**RE: Dézé Energy Response to April 14<sup>th</sup> Information Requests from Parks Canada, Environment Canada, Indian and Northern Affairs Canada, and property owners in the area.**

## TALTSON EXPANSION PROJECT RESPONSE TO ROUTING INFORMATION REQUESTS

**Figure 1. Water and Ice Measurement Transect – March 2010**

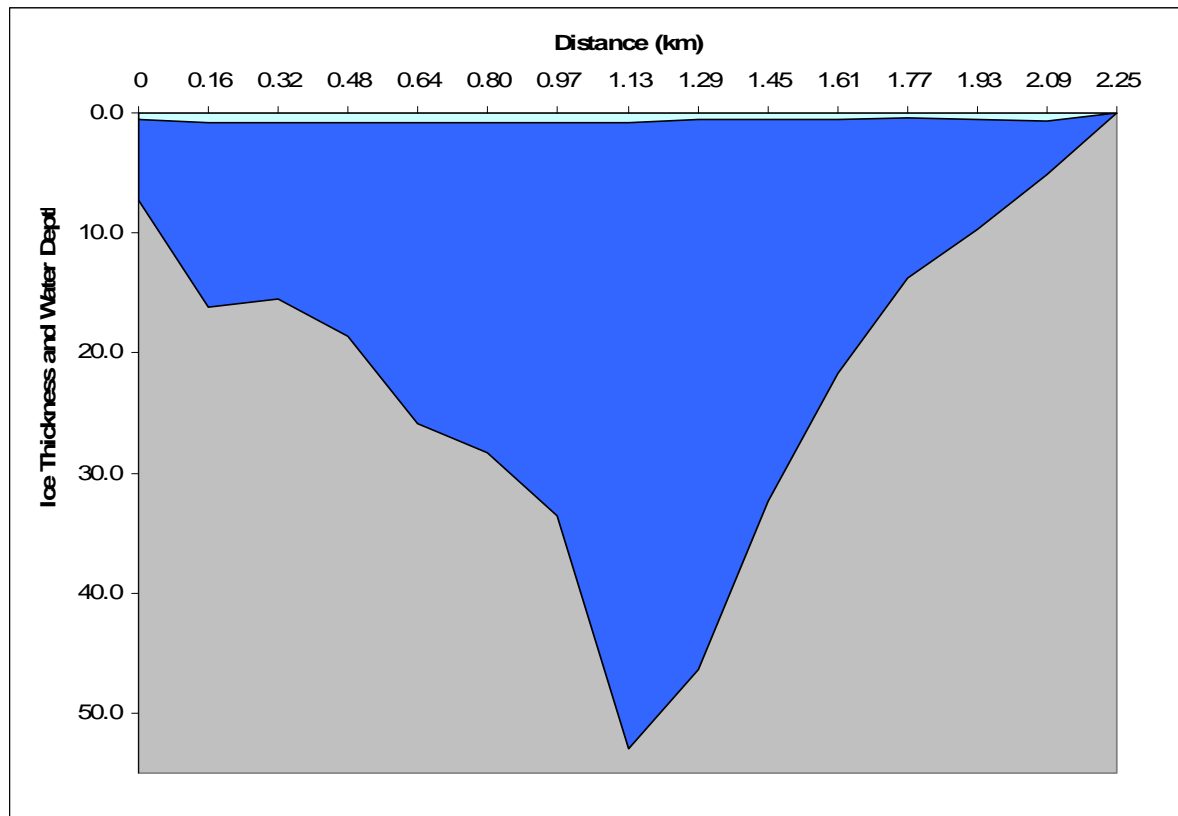
6. Additional details on the depth and sediment types at the underwater crossing between Maufelly Point and Fairchild Point;
7. A description of the rock fracturing that may be required and the methods anticipated to conduct this fracturing and excavation;
8. The details associated with the burial of cables at depth, if necessary, and near shore (including the required depth and width of any channelling);
9. The methods and material requirements to cover the cables such that ice abrasion, scouring and erosion does not occur during placement and over time; and
10. Details on the description of the work and whether machinery will be required to work within the water and near the shoreline.

The marine cable was proposed to be laid on the lake bottom; therefore, preliminary crossing location depth and cross-sectional information was gathered in March 2010 and is shown in figures 1 and 2 below.

Based on the preliminary depth measurements, the crossing location depths are amiable for placement of an underwater cable. As the works would be conducted according to the Fisheries and Oceans Canada, Northwest Territories Operational Statement: Underwater Cables (V.3), effects to fish and fish habitat would be mitigated. This would include water quality associated with bottom sediment conditions and machine use in near-shore environments, among others. In addition, the DFO Operational Statement also requires that.

**Figure 1. Viewshed Analysis Results, East Arm Area**

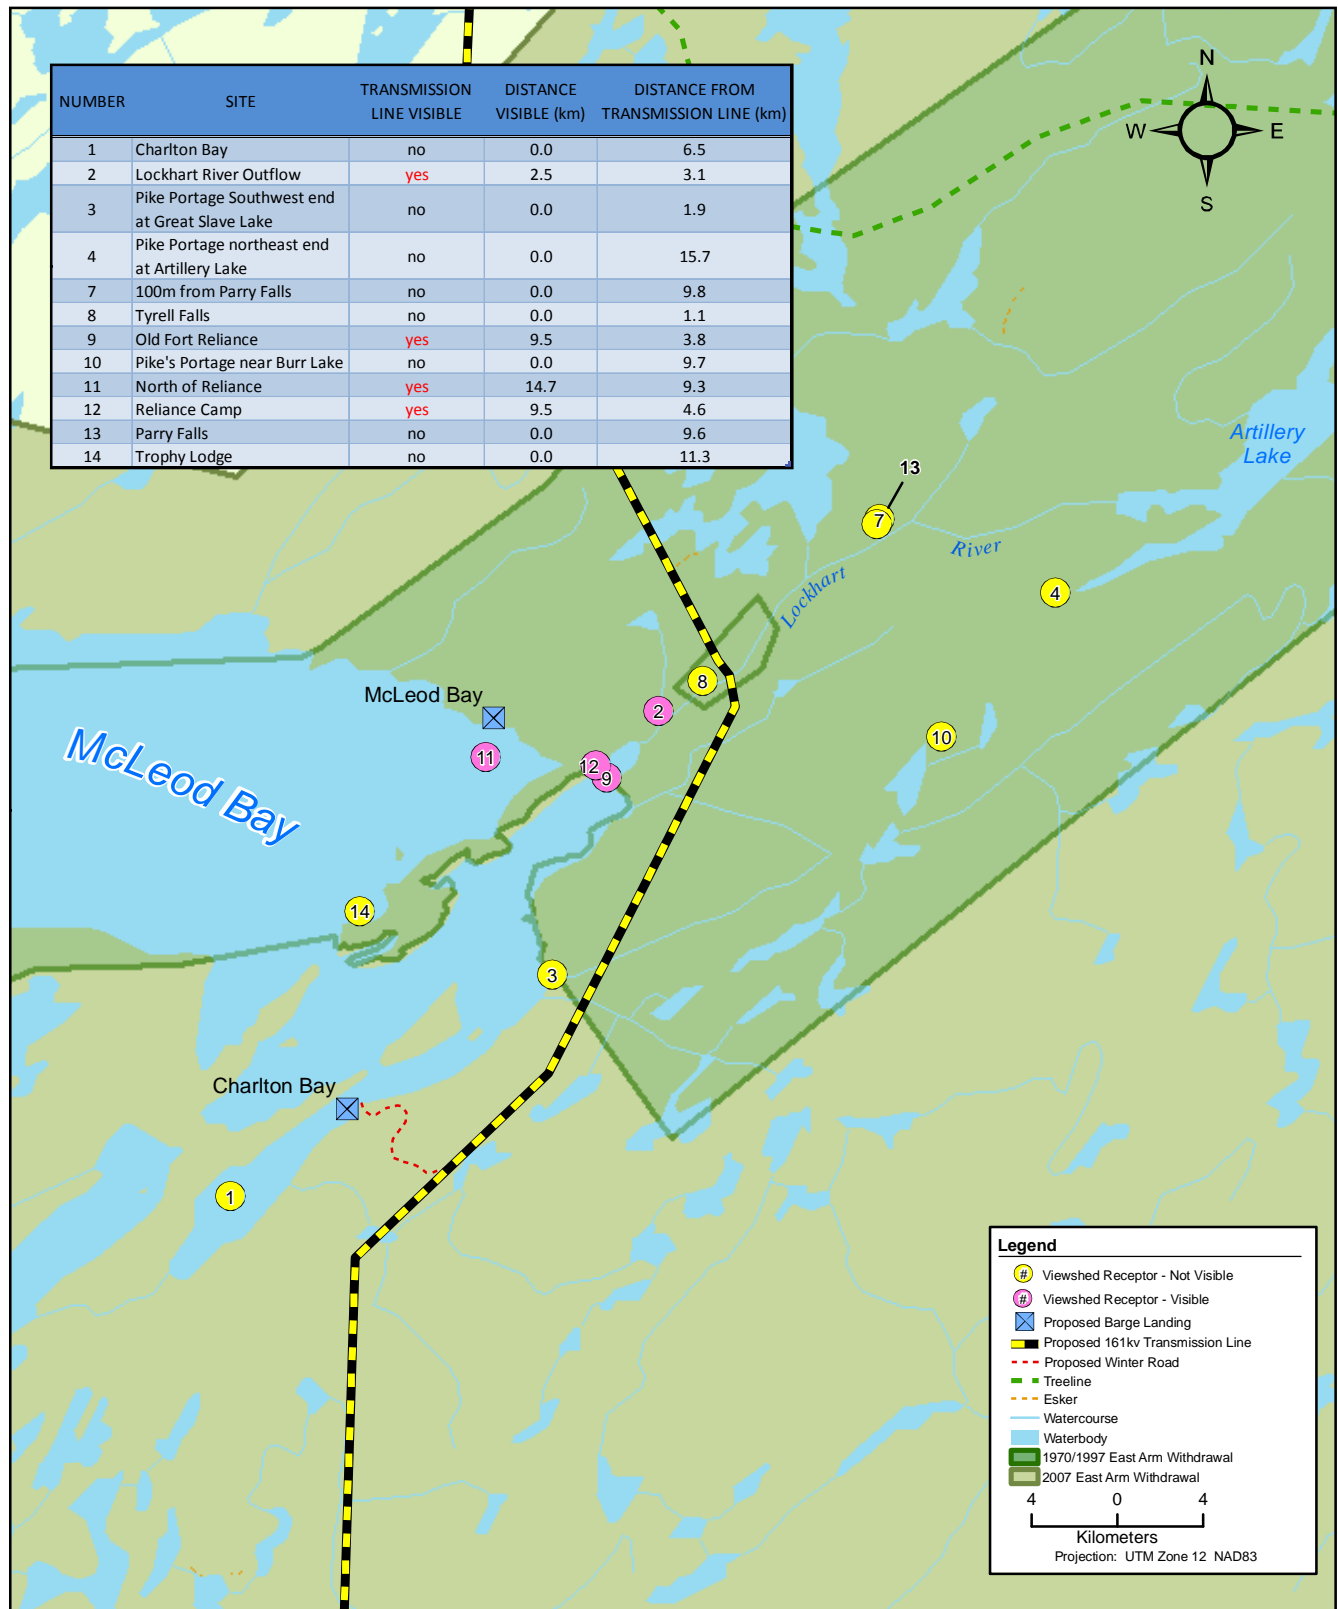
7. That the Dézé Energy Corporation expand the viewshed analysis in the DAR (Table 15.10.5) adding an analysis from the following key viewpoints, as identified by Parks Canada: Tyrell Falls, Pike's Portage near Burr Lake, Parry Falls (Old Lady of the Falls) 100 m upstream, and Old Fort Reliance National Historic Site

The results of the viewshed analysis are shown in Figure 1, and Table 1. The analysis assumed a transmission tower height of 25 m, and an observer height of 2 m. The effect of trees in reducing visibility was not incorporated into the model. The viewshed analysis is also limited by the detail of the topographic information in the East Arm region. In these situations, the model has a tendency to even out local variations in topography, and over-estimate the extent of the viewscape. Also, the final engineering and tower placement has not yet been conducted. The model shows only the line of sight from an observer to the transmission line, and does not consider whether the transmission line can actually be seen with the naked eye from that distance. In practice, transmission lines are probably difficult to see at distances of more than 5 km.

The results of the viewshed analysis indicate that the preferred route of the transmission line would be within the line of sight from the Lockhart River outflow (i.e. the last set of rapids on the Lockhart River before Great Slave Lake), Old Fort Reliance, the Reliance Camp, and from North of Reliance (a point on Great Slave Lake, but over 9 km from the transmission line, see Figure 1). The analysis indicated that the transmission line would not be within the line of sight from either end of Pike Portage, Parry Falls (and upstream of Parry Falls by 100 m), Tyrell Falls, or Trophy Lodge.
